16632 WILD CHERRY LN

RE: Property located on 16632 Wild Cherry Lane
FILE: 496B/8368A
PARCEL: 139-173-47

MECKLENBURG COUNTY ENVIRONMENTAL HEALTH
SITE EVALUATION REPORT
SERIAL NUMBER 12725

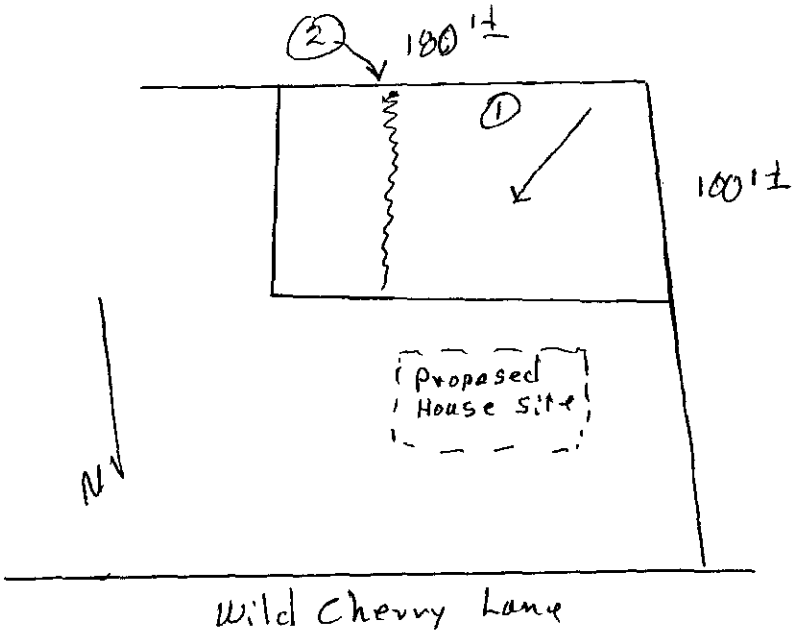
Comments: 100% Repair, system would probably need lift pump

FACTORS	AREA 1	AREA 2	AREA 3	AREA 4	AREA 5	AREA 6
Topography	(S) PS U 2-8%	S PS (U) complex slopes	S PS U	S PS U	S PS U	S PS U
Texture	S (PS) U slightly Expansive clay	S PS U —	S PS U	S PS U	S PS U	S PS U
Structure	S (PS) U Sub ∠ Blocky	S PS U —	S PS U	S PS U	S PS U	S PS U
Drainage	S (PS) U 740" TO water	S PS U —	S PS U	S PS U	S PS U	S PS U
Depth	S (PS) U 40"+	S PS U —	S PS U	S PS U	S PS U	S PS U
Restrictive Horizons	S (PS) U 740"	S PS U —	S PS U	S PS U	S PS U	S PS U
Available Space	S (PS) U	S PS U	S PS U	S PS U	S PS U	S PS U
Other (specify)	S PS U	S PS U	S PS U	S PS U	S PS U	S PS U
Soil Group/Series	IV Cecil-Hiwe	Complex slopes				
Area Classification	S (PS) U	S PS (U)	S PS U	S PS U	S PS U	S PS U

MECKLENBURG COUNTY ENVIRONMENTAL HEALTH
SITE EVALUATION REPORT
SERIAL NUMBER № 12725

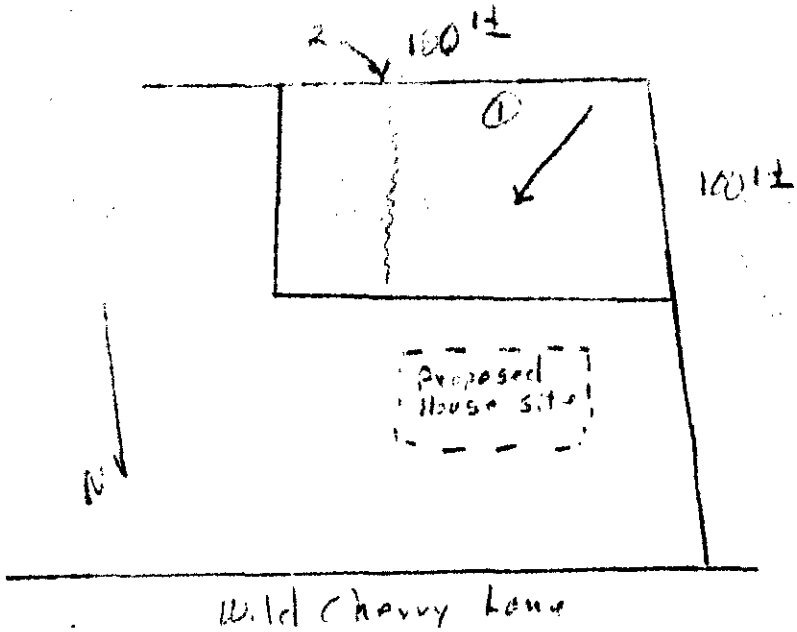
FACTORS	AREA 1	AREA 2	AREA 3	AREA 4	AREA 5	AREA 6
Topography	S (PS) U 2-6 %	S PS (U) [illegible]	S PS U	S PS U	S PS U	S PS U
Texture	S (PS) U slightly Expansive clay	S PS U —	S PS U	S PS U	S PS U	S PS U
Structure	S (PS) U Sub-Angular Blocky	S PS U —	S PS U	S PS U	S PS U	S PS U
Drainage	S (PS) U Wet Weather	S PS U —	S PS U	S PS U	S PS U	S PS U
Depth	S (PS) U 40"+	S PS U —	S PS U	S PS U	S PS U	S PS U
Restrictive Horizons	S (PS) U 40"	S PS U —	S PS U	S PS U	S PS U	S PS U
Available Space	S (PS) U	S PS U	S PS U	S PS U	S PS U	S PS U
Other (specify)	S PS U	S PS U	S PS U	S PS U	S PS U	S PS U
Soil Group/Series	IV Cecil-like	Complex slopes				
Area Classification	S (PS) U	S PS (U)	S PS U	S PS U	S PS U	S PS U
